Re: Docket No. 508 - The United Illuminating Company Application for a Certificate of Environmental Compatibility and Public Need for the Milvon to West River Railroad Transmission Line 115-kV Rebuild Project

Enclosed for filing with the Connecticut Siting Council ("Council") is the United Illuminating Company's ("UI" or the "Company") responses to the Council's April 1, 2022 interrogatories (Set One), Affidavit of Shawn Crosbie relating to sign posting and the Company's pre-hearing submission.

Map showing the location of Charles Island relative to the Project Corridor

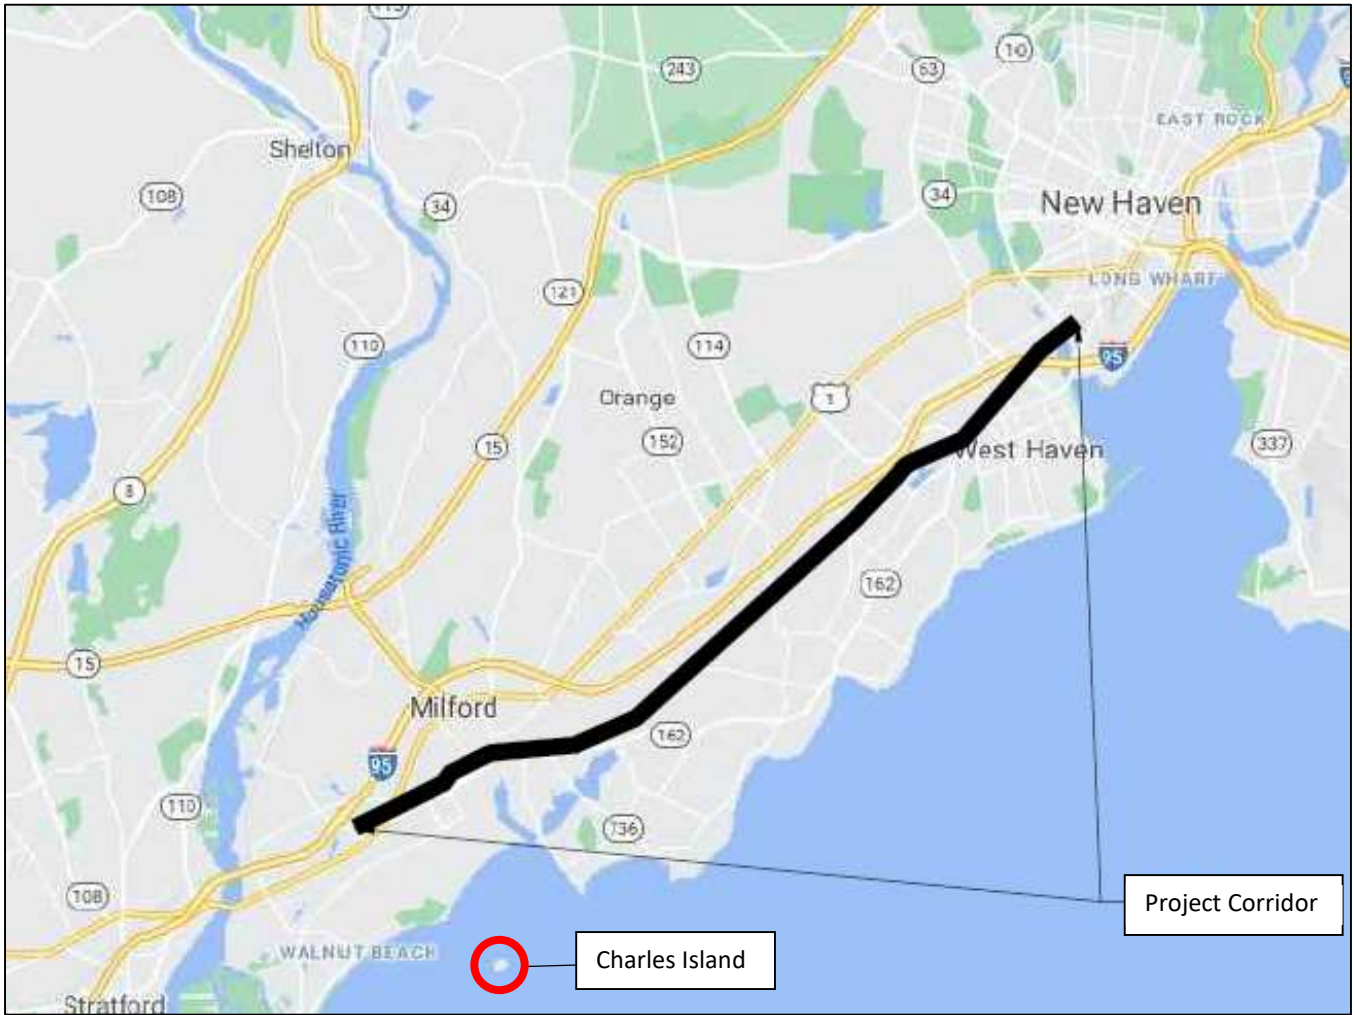
- a) Where is Charles Island located? Please provide a map.
- b) What is the closest distance between the proposed project and Charles Island?
- c) Would the proposed project be visible from Charles Island? Please characterize any visibility.
- d) How does SHPO's recommendation for historic research of Charles Island and installation of interpretive signage on Charles Island mitigate the indirect visual impacts of the proposed project from the 5 identified historic properties?
- e) Does UI have an in-house historian?
- f) Would the costs of performing SHPO's recommended historic research of Charles Island and installation of interpretive signage on Charles Island be recovered from the ratepayers?

A-CSC-43: a) Charles Island is located approximately 0.5 mile off the coast of Milford. Please see the attached figure. CSC-43-1.

Docket 508
Response to Interrogatory 47
Existing Conditions Viewshed Analysis Map
Milvon-West River Railroad Transmission
Line 115-kV Rebuild Project

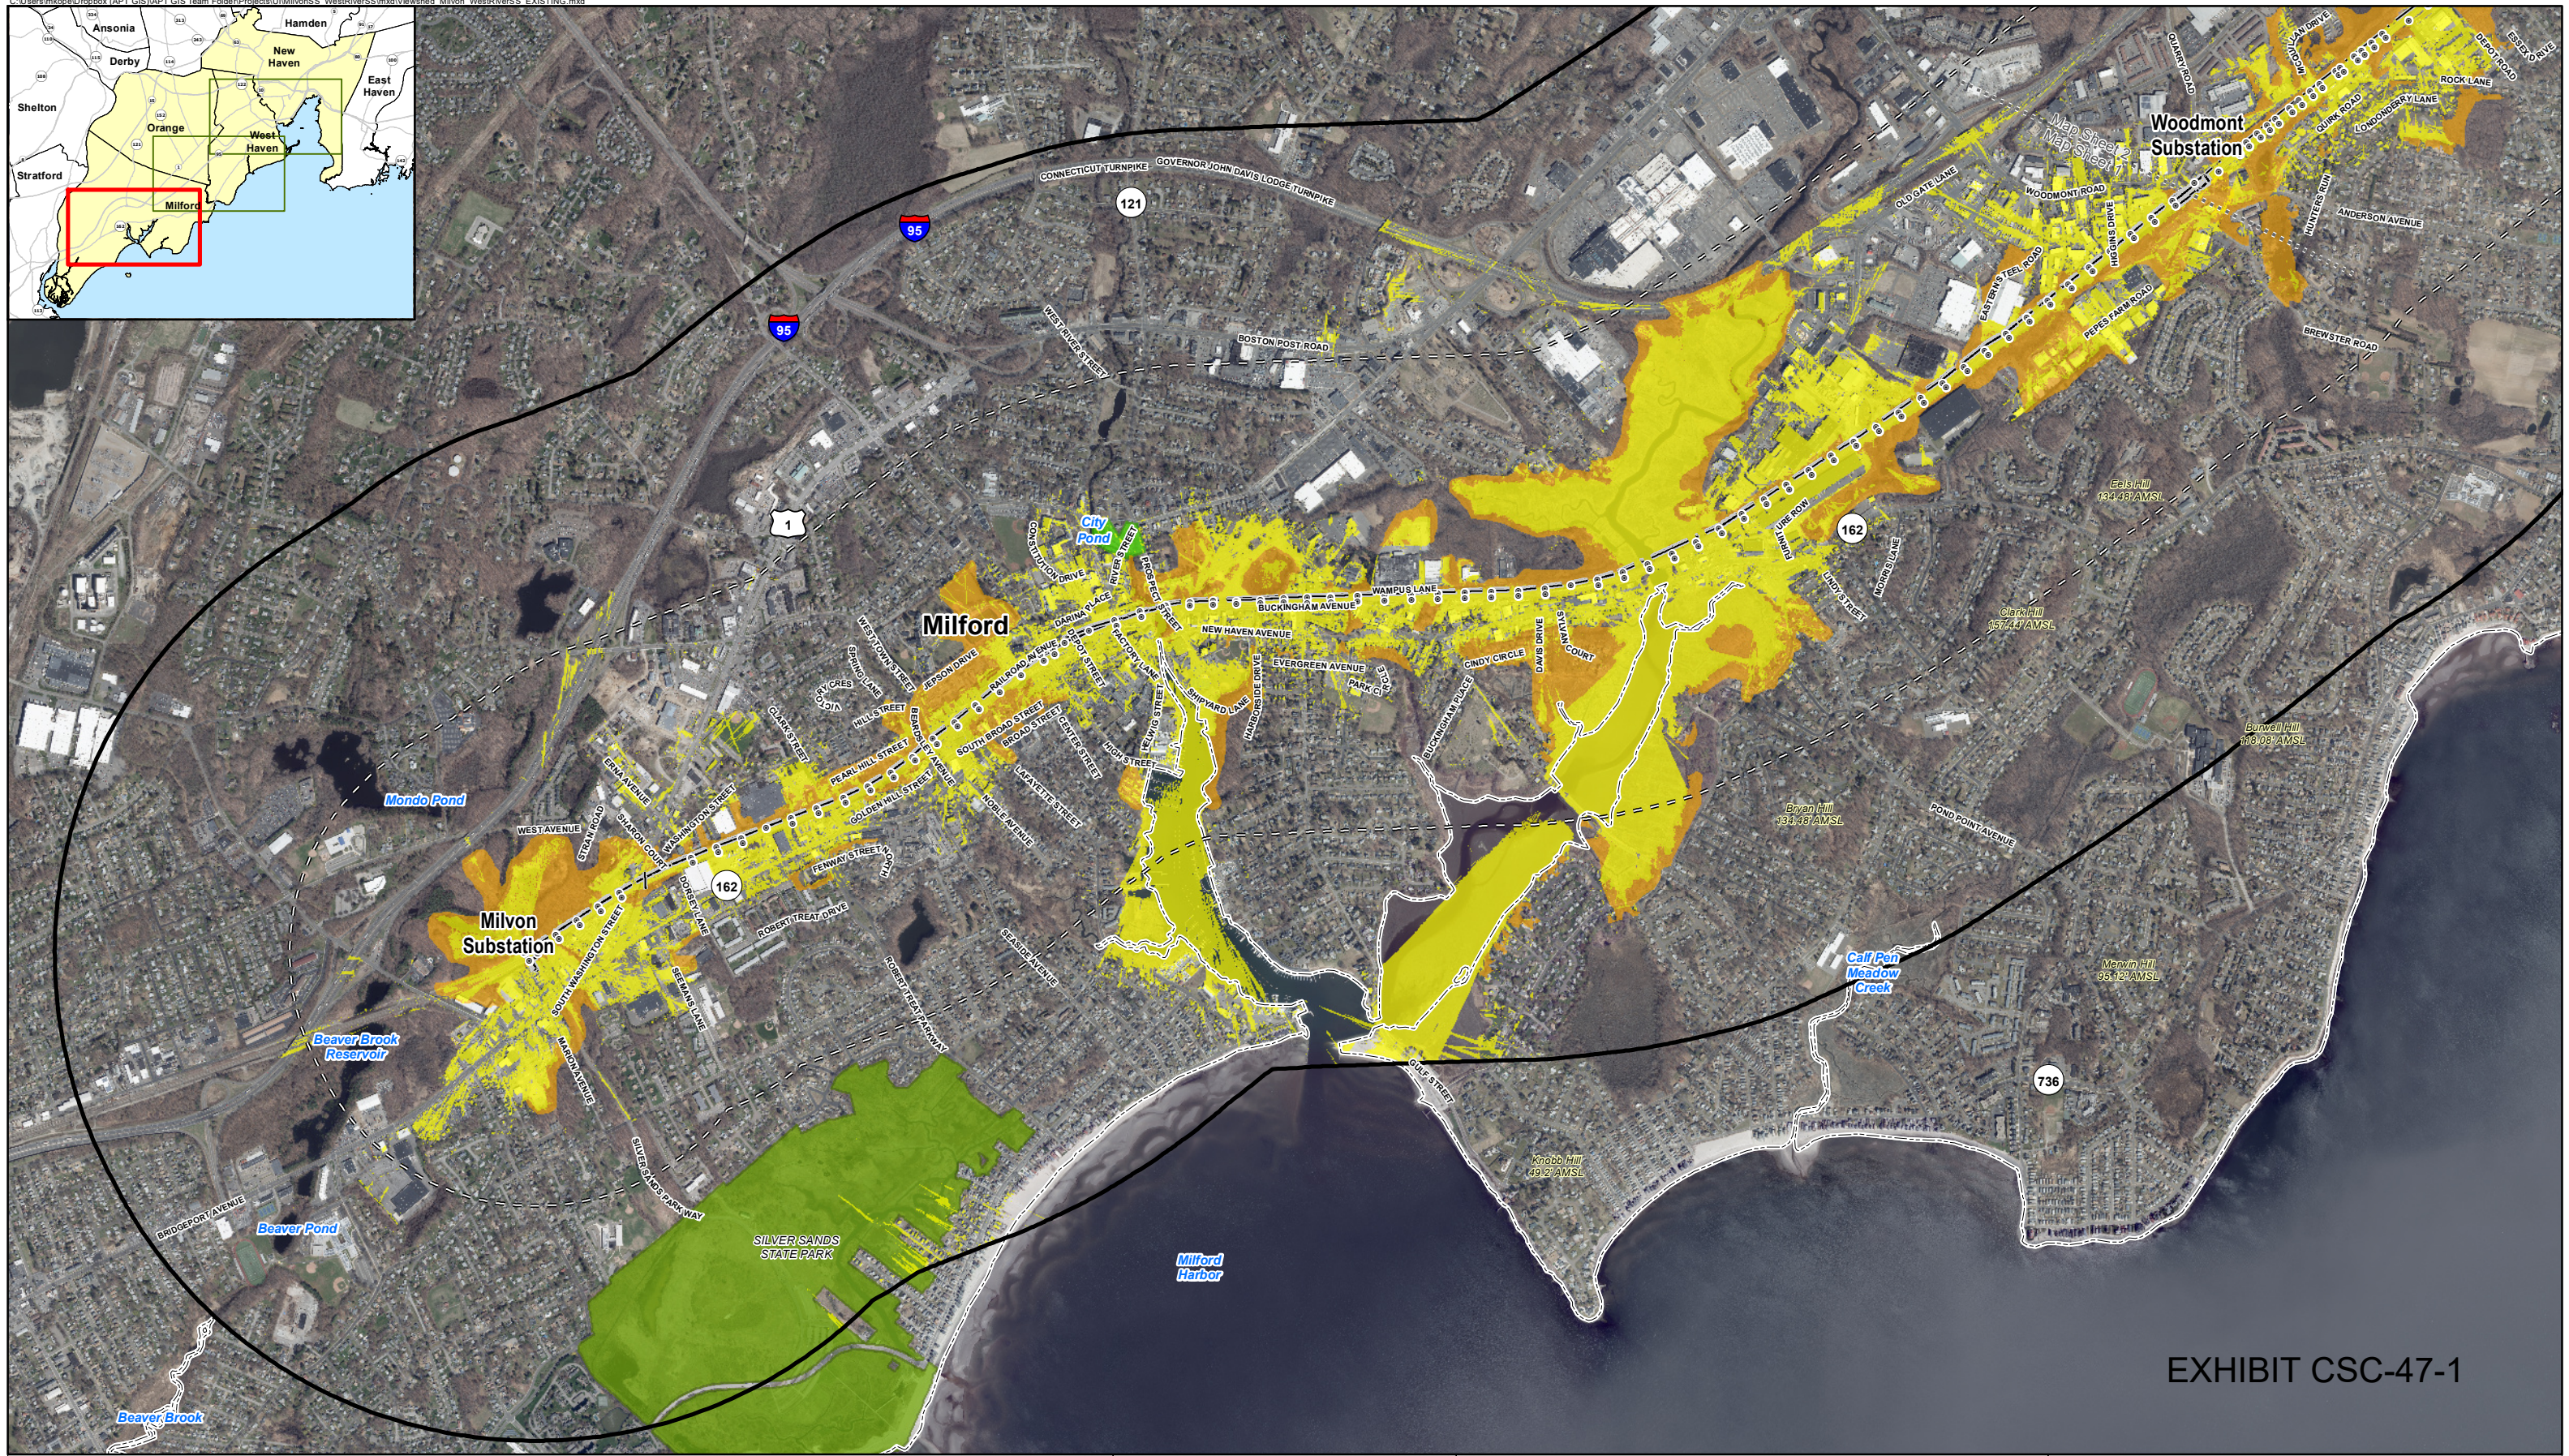
- Q-CSC-47: Referencing Appendix C of Volume 1A of the Application, Viewshed Analysis Maps 1 through 3, as a comparison, provide similar viewshed maps based on the existing catenaries only. Of the approximately 14,015-acre (or one-mile radius) study area, about how many acres have year-round views of the existing catenaries, and how many acres have seasonal views of existing catenaries?

- A-CSC-47: Viewshed maps depicting visibility associated with existing catenaries with the UI facilities (bonnets, hardware and 115 kV conductor) are provided and attached. See CSC-47-1. Approximately 1,673 acres (12% of the Study Area) have year-round views of the existing catenaries and UI facilities approximately 477 acres (3.4% of the Study Area) have seasonal views of the existing catenaries. These acreages are approximately half that of the proposed project upgrades since existing catenaries are substantially lower than the new monopoles. Please note that this response does not include the heights of the 21 existing UI structures listed in Table 2-2 of the Application.
